Marin County Flood Control and Water
Conservation District
**Corte Madera Creek Flood Risk Management
Project, Phase 1**
Final Environmental Impact Report
Volume 1: Comments and Responses to Comments
State Clearinghouse No. 2020080353

**Marin County Flood Control and Water
Conservation District
Corte Madera Creek Flood Risk Management
Project, Phase 1
Final Environmental Impact Report
Volume 1: Comments and Responses to Comments
State Clearinghouse No. 2020080353**

Figure 2-7 Alternative 1 Changes in Water Surface Elevation from Future Conditions, 10-Year Flood Event (Upper Corte Madera Creek)

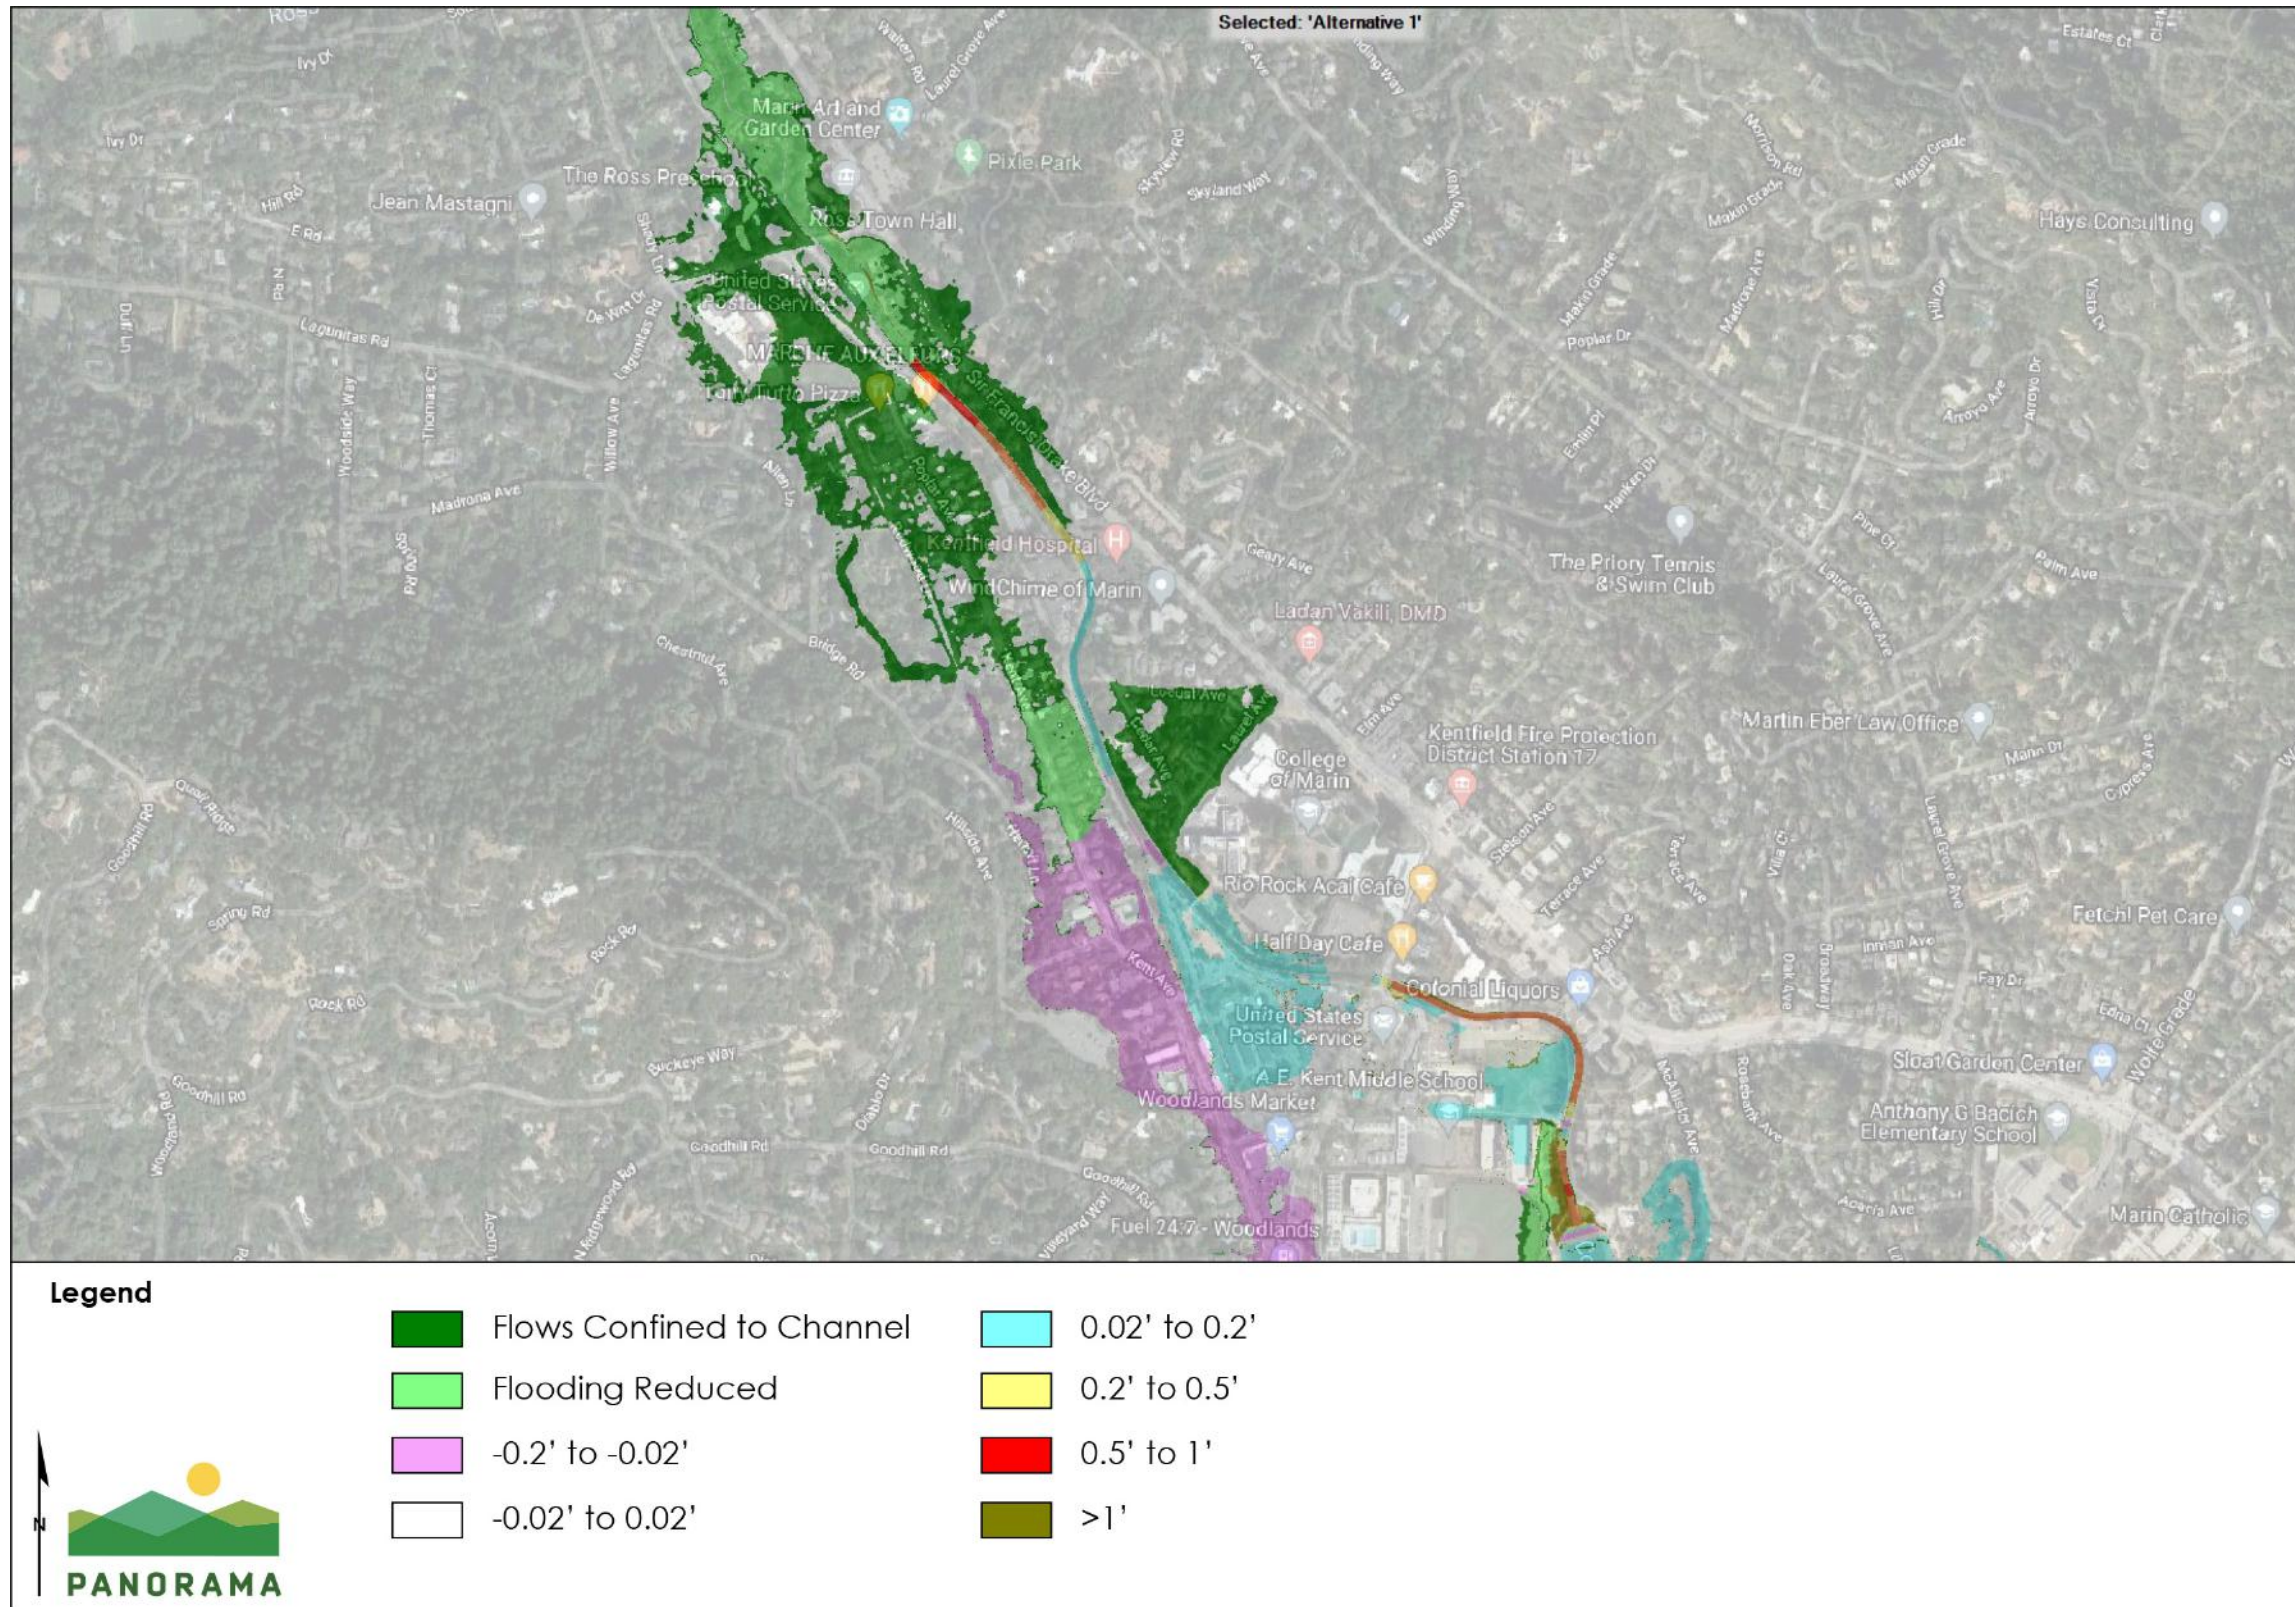
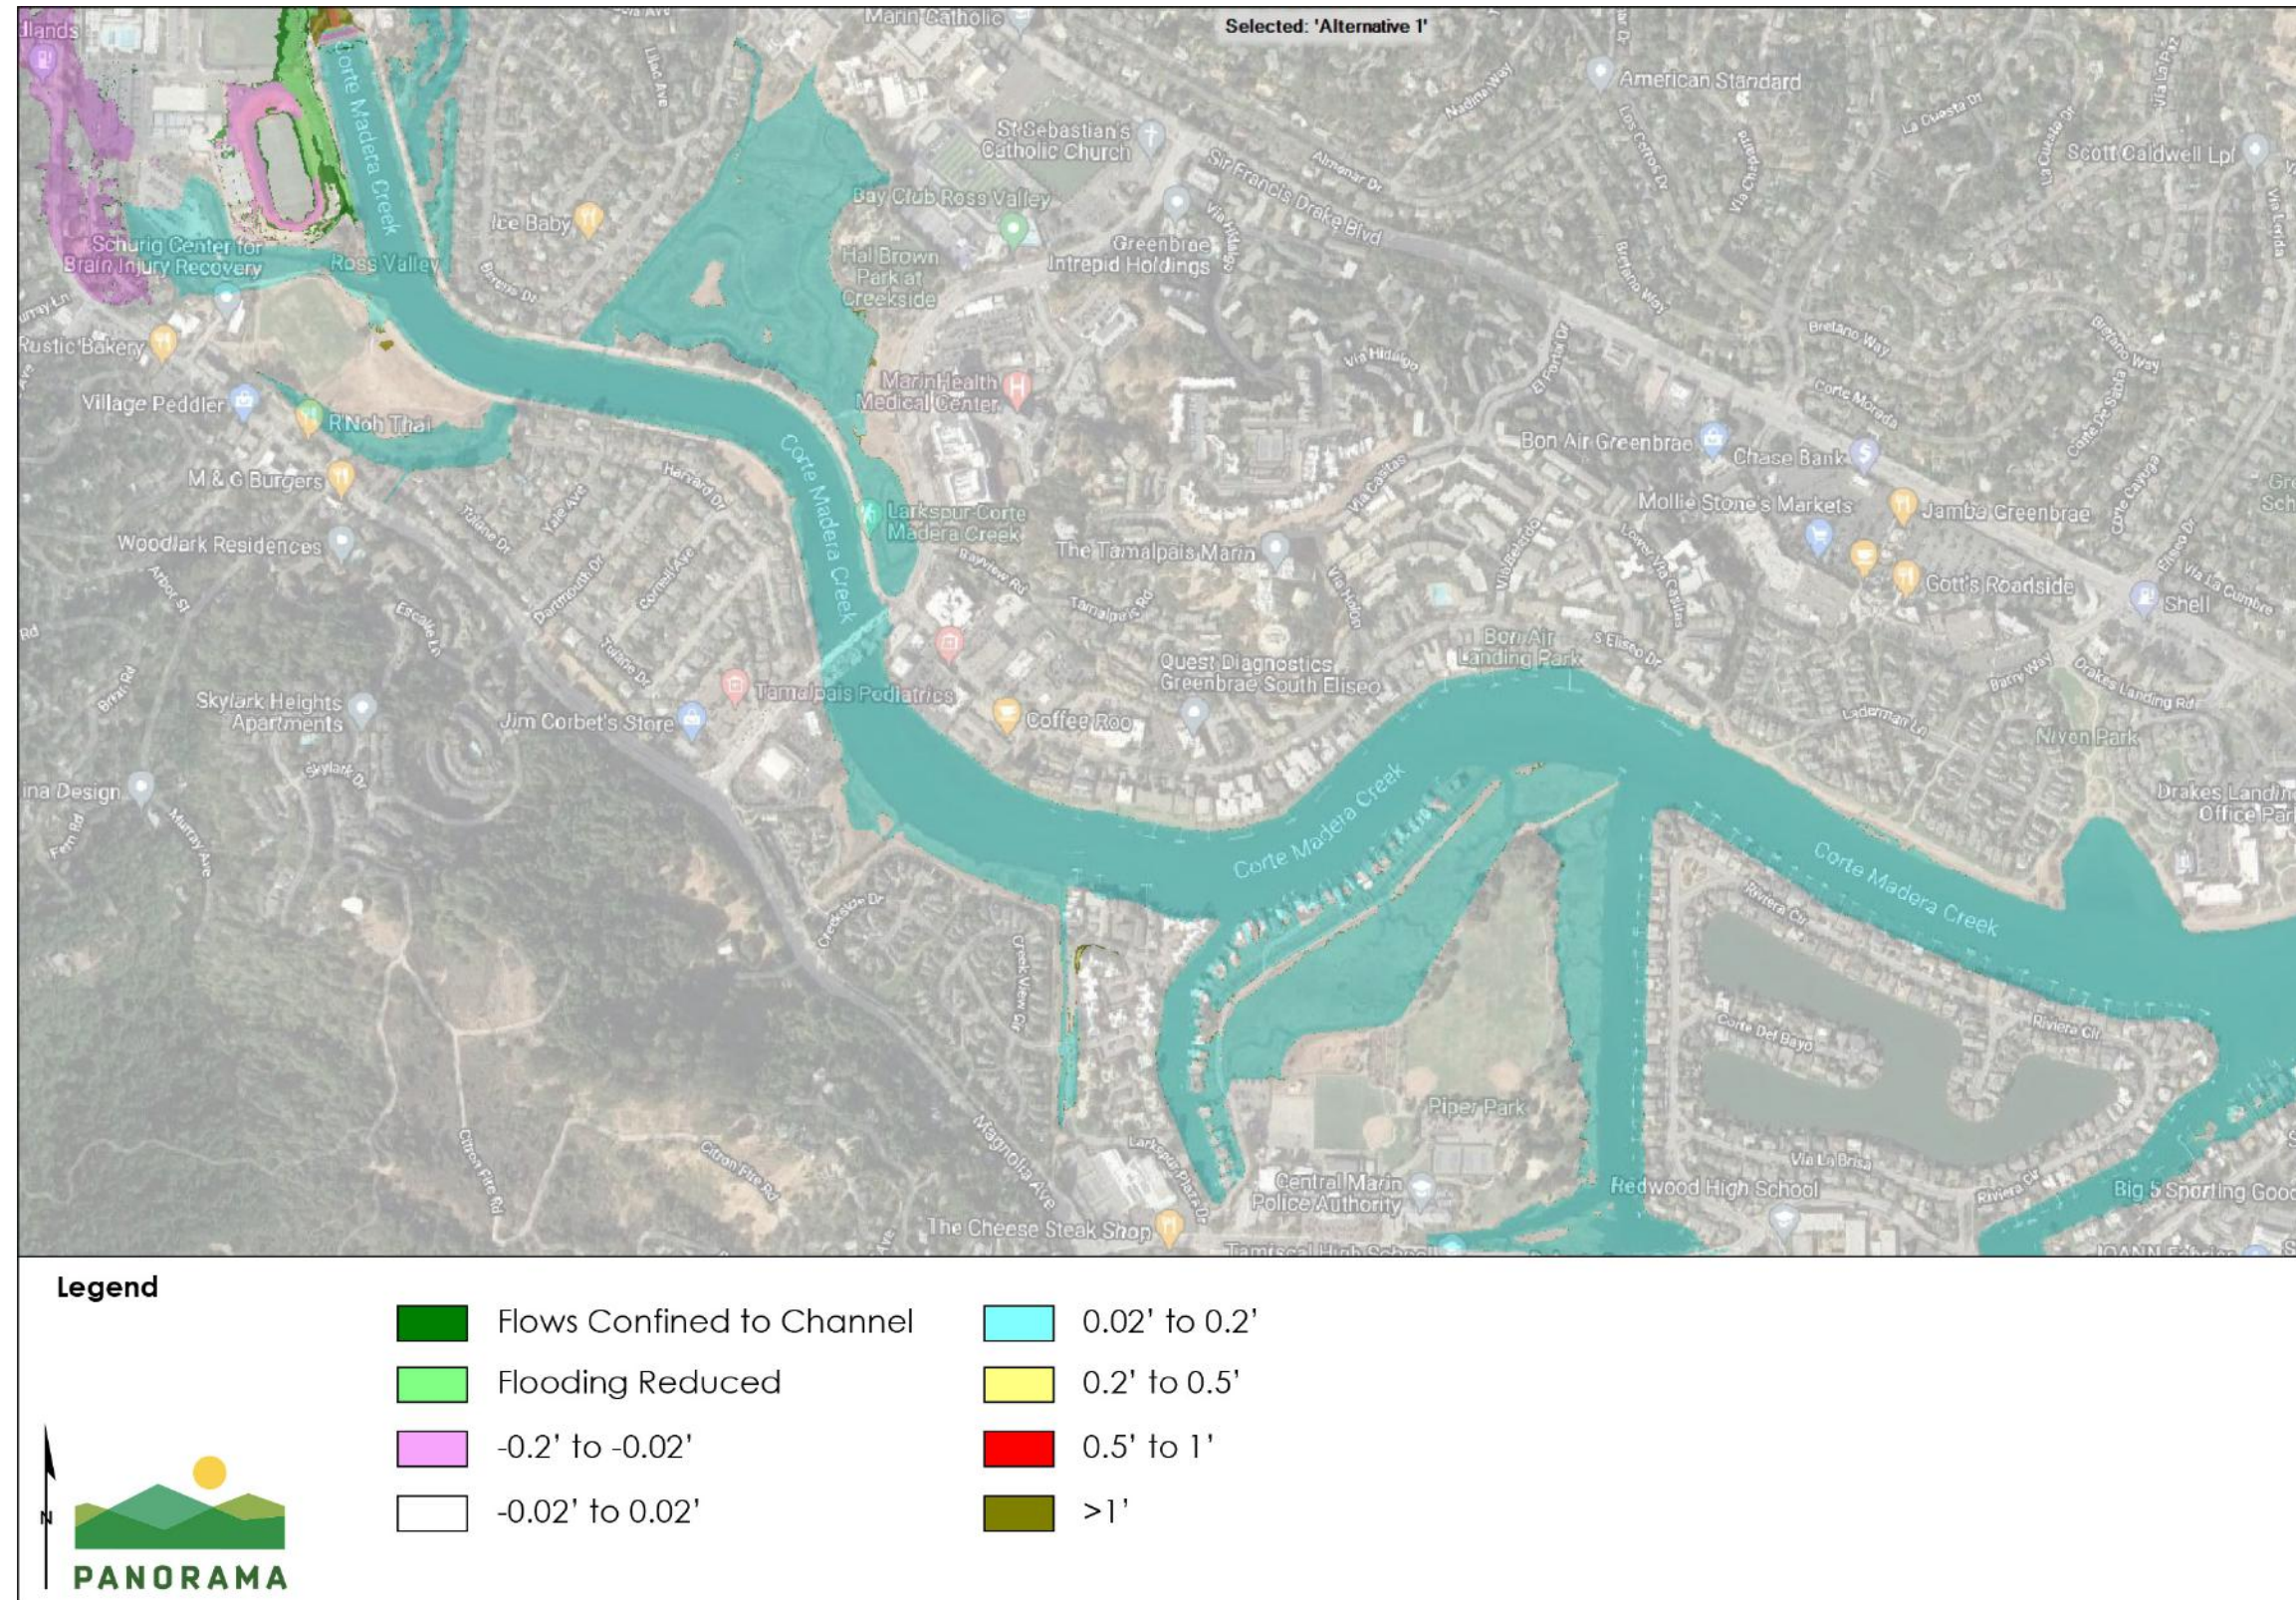
The geographic extent of the figures showing the changes in WSE differs from the figures included in the Draft EIR. The geographic extent of the figures was expanded to show areas downstream from Unit 2 in response to comments from the City of Larkspur. As discussed on page 3.9-39 in the Draft EIR, a threshold of 0.2 foot (2.4 inches) was used for determining whether a potentially significant increase or decrease in WSE would occur at any structure. The 0.2-foot threshold is a reasonable level of precision for evaluating flooding impacts, considering the standards for accuracy and precision associated with hydraulic modeling.

Figure 2-1 through Figure 2-6 show the Alternative 1 changes to the WSE and reflect the difference in WSE between the Existing Condition Without Project and Existing Condition With Alternative 1 scenarios under a 10-, 25-, and 100-year flood, using the updated modeling for the 60 percent design. Figure 2-7 through Figure 2-12 show the Alternative 1 changes to the WSE under for the future condition scenario, and reflect the difference in WSE between the Future Condition Without Project and Future Condition With Alternative 1 under the 10-, 25-, and 100-year flood conditions. The assumptions used in the future condition modeling are described on pages 3.9-35 through 3.9-37 in Section 3.9 in the Draft EIR and are supplemented by the model updates described above. Figure 2-13 through Figure 2-18 show the Alternative 1 changes to the WSE under a “high-emissions likely” sea-level rise scenario, to reflect 2100 projected sea-level rise based on the 2018 Update of the State of California Sea-Level Rise Guidance (California Ocean Protection Council, 2018). Figures 2-13 through 2-18 reflect the difference in WSE between the Year 2100 Future Condition Without Project and Year 2100 Future Condition with Alternative 1 scenarios under the 10-,25-, and 100-year flood conditions.

Areas shown in the figures as “Flows Confined to Channel” are areas that are currently flooded by Corte Madera Creek, which are predicted to no longer have flood inundation from Corte Madera Creek overtopping after Alternative 1 is implemented. Areas shown in the figures with “Flooding Reduced” are areas with reduced flood inundation (greater than 0.2 foot) from creek overtopping after Alternative 1 is implemented. The change in WSE shown on the maps reflects a comparison between WSE without implementation of Alternative 1 and the WSE after implementation of Alternative 1 for each modeled scenario.
